August 3, 1984

HOPE CREEK GENERATING STATION  
DOCKET NO. 50-354  
DRAFT SAFETY EVALUATION REPORT  
OPEN ITEM STATUS

In addition, enclosed for your review and approval (see Attachment 4) are the resolutions to the Draft SER open items, FSAR question responses and structural geotechnical audit item responses, listed in Attachment 3.

TABL. 3.4-3

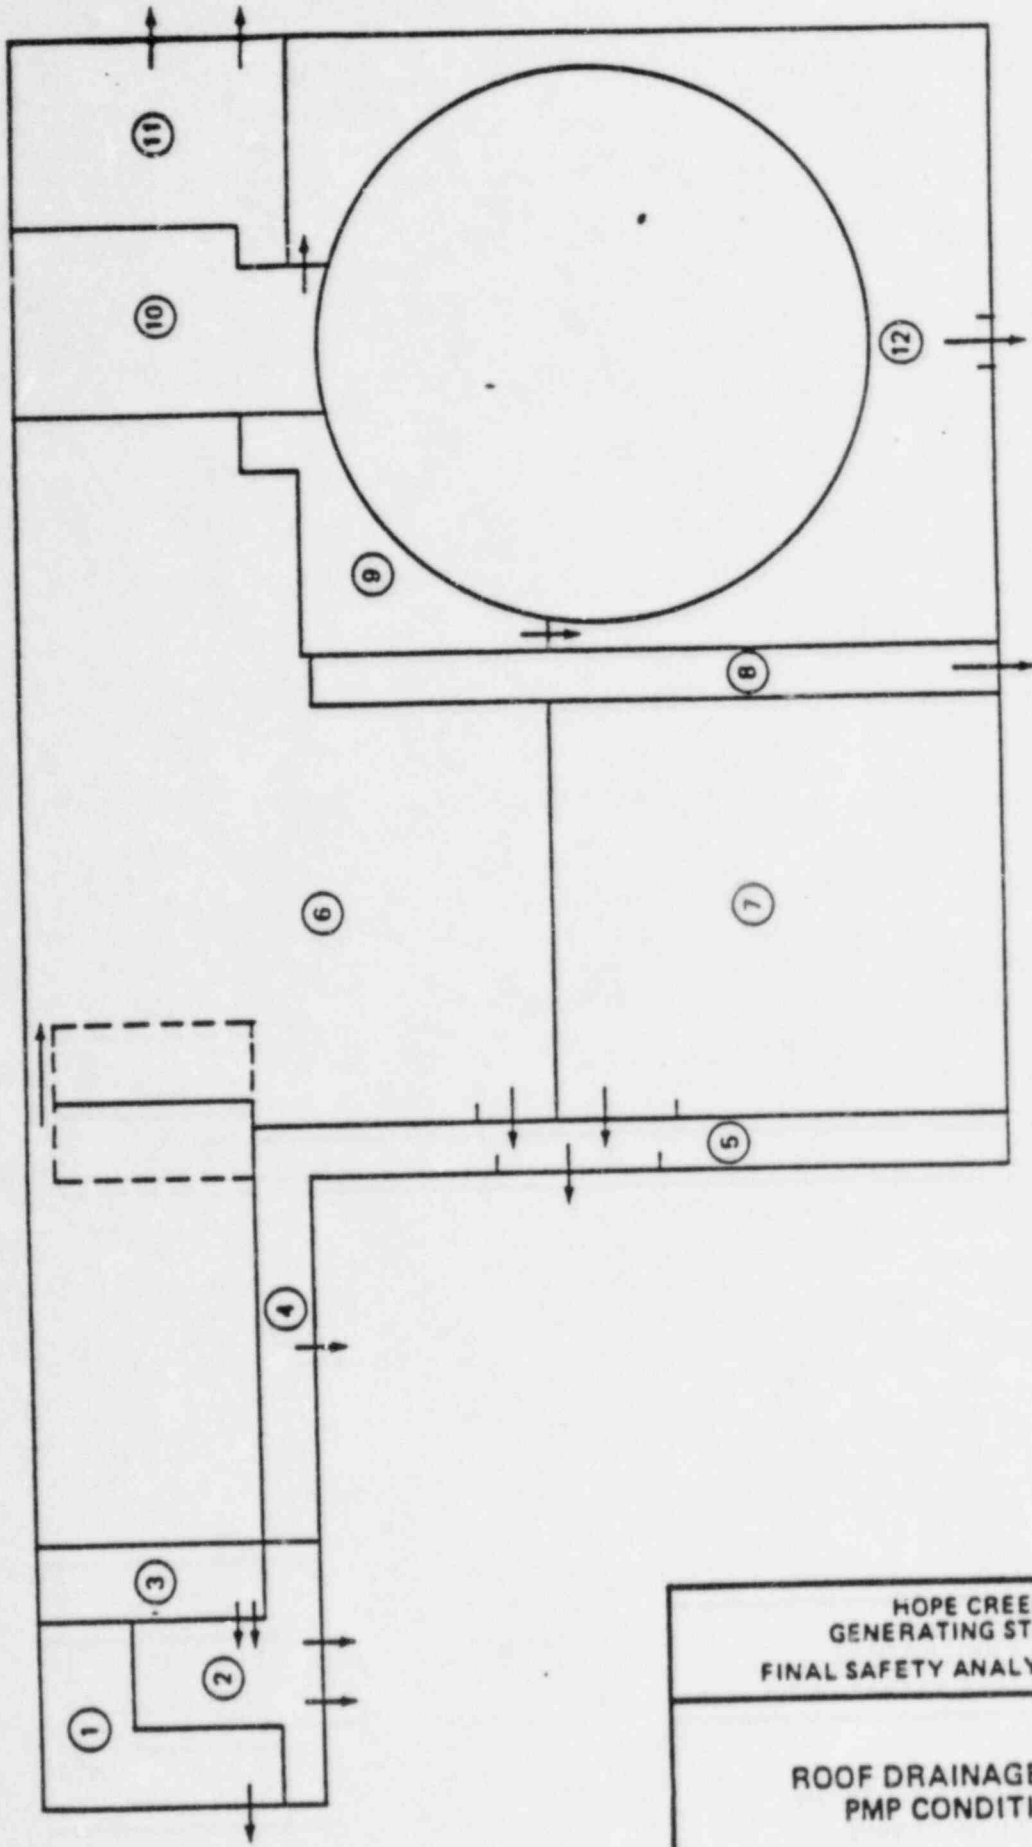
Provide your detailed analysis of the PMP ponding levels on roofs of safety-related structures requested in Q240.7. Details should identify and provide information on the roof area of each sub-drainage area for each safety-related structure; the size, number and distance above roof (elevation) of the invert of each scupper (overflow drain) for each drainage system, and the elevation of the curb of each roof hatch within each roof drainage area system. Also provide details used to conclude that the ponding resulting from PMP does not effect safety-related facilities.

Except for the intake structure, the HCGS safety-related structures are provided with roof drainage systems capable of handling a maximum rainfall rate of 4 inches per hour for a period of 20 minutes. In the unlikely event that the roof drains become clogged, redundant overflow drains are provided approximately 6 inches above the main roof drain elevations except for the plant cancelled area, which has no parapets. The roof drainage system disposes water through the yard drainage system. To preclude ponding for significantly greater rainfall intensities segments of the parapets are removed where necessary.

Figure A-13-1  
Division of Responsibility

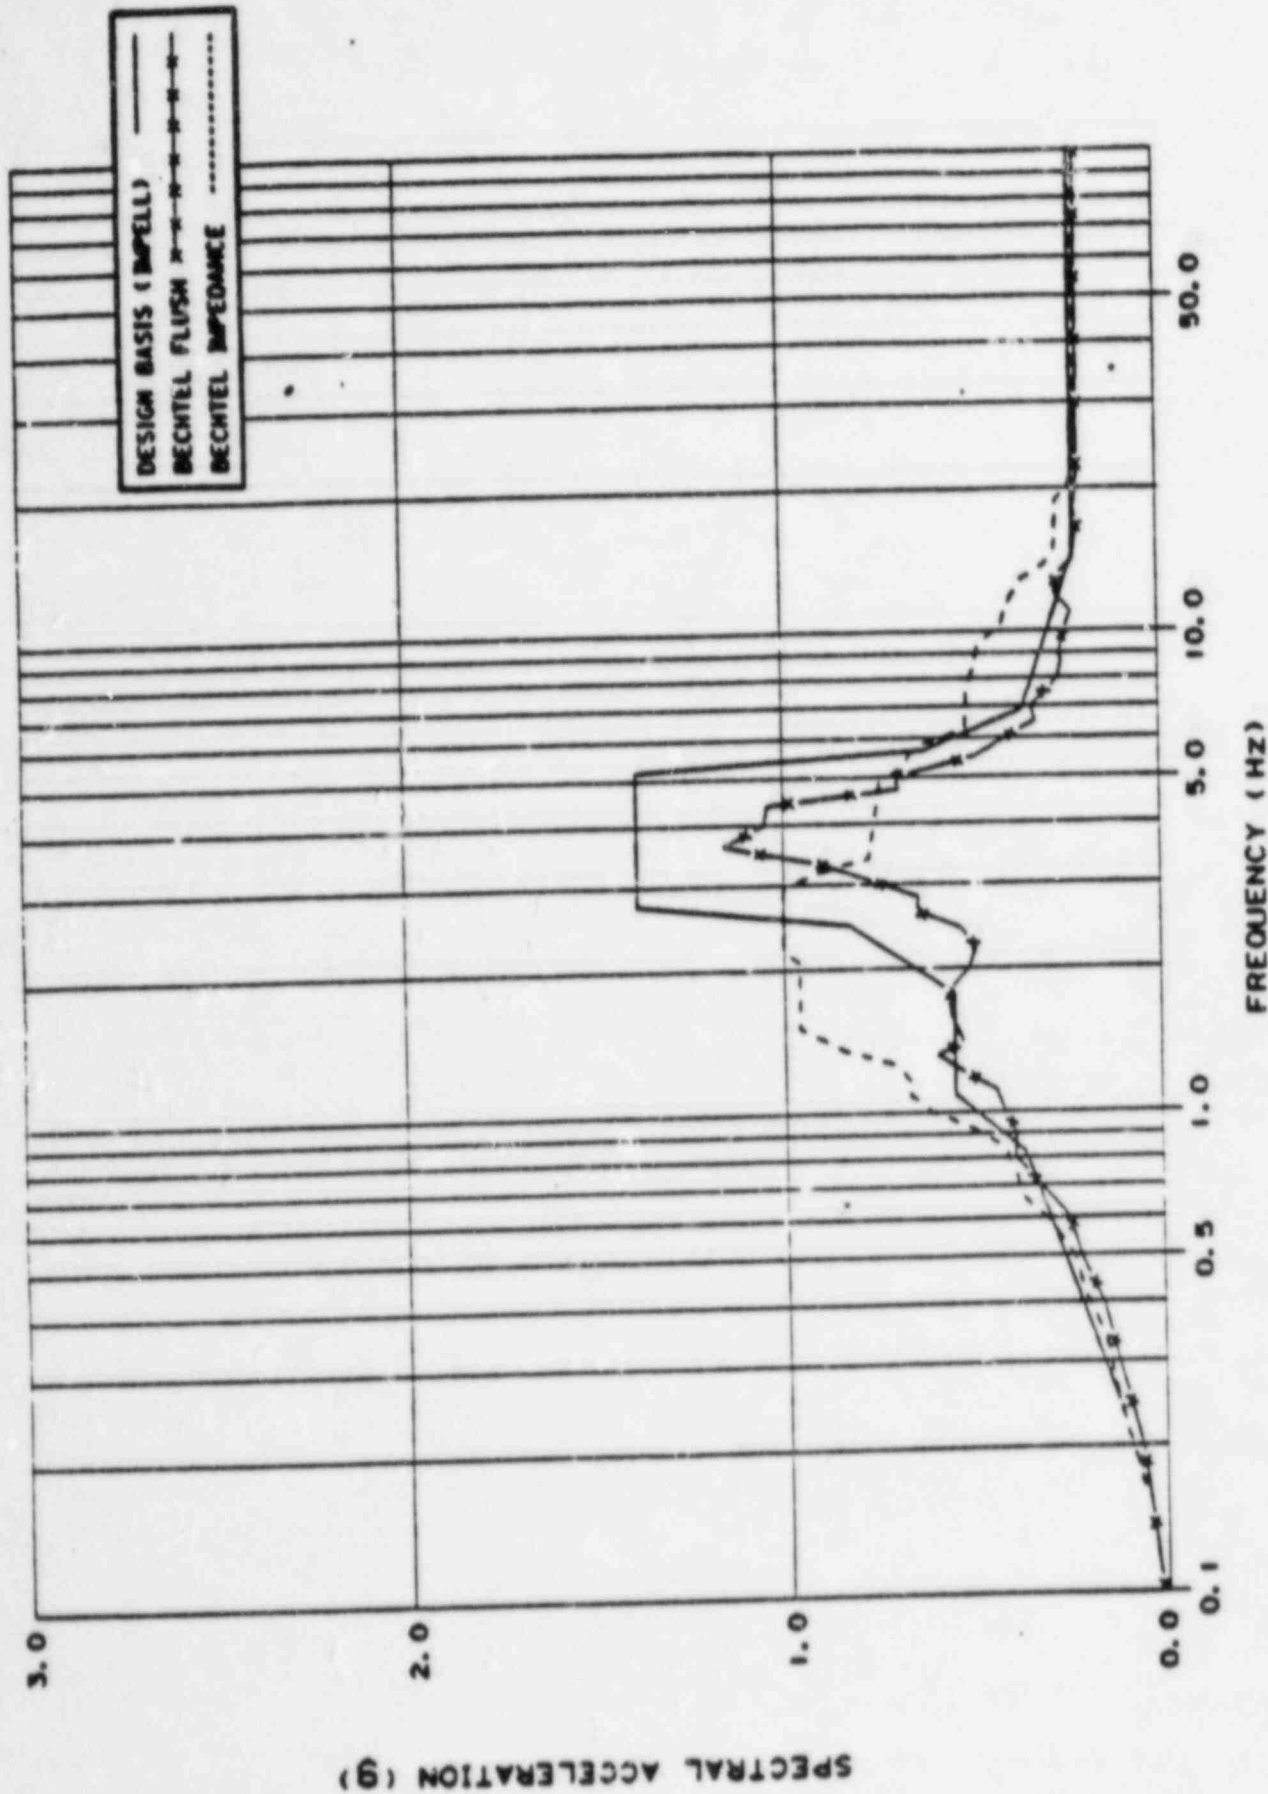
Question: Provide comparison of Bechtel Independent Verification Results with the Design Basis Results.

As described in Amendment 1 of the FSAR (Section 3.7.2.4), three independent seismic soil-structure interaction analyses are performed for the major plant structures. The design basis analyses are performed using the finite element method by EDS Nuclear, Inc. (presently known as Impell Corporation). Independent finite element soil-structure interaction analyses are subsequently performed by Bechtel to verify the design basis analyses. In addition, in accordance with the requirements of the Standard Review Plan, Section 3.7.2 (NUREG 0800), impedance approach (the half-space) soil-structure interaction analyses are performed by Bechtel. The analytical method utilized for the impedance approach seismic soil-structure interaction analyses of power block structures and service water intake structure is given in FSAR Section 3.7.2.1. Figure A-13-1 summarizes the division of responsibilities for the seismic analyses.
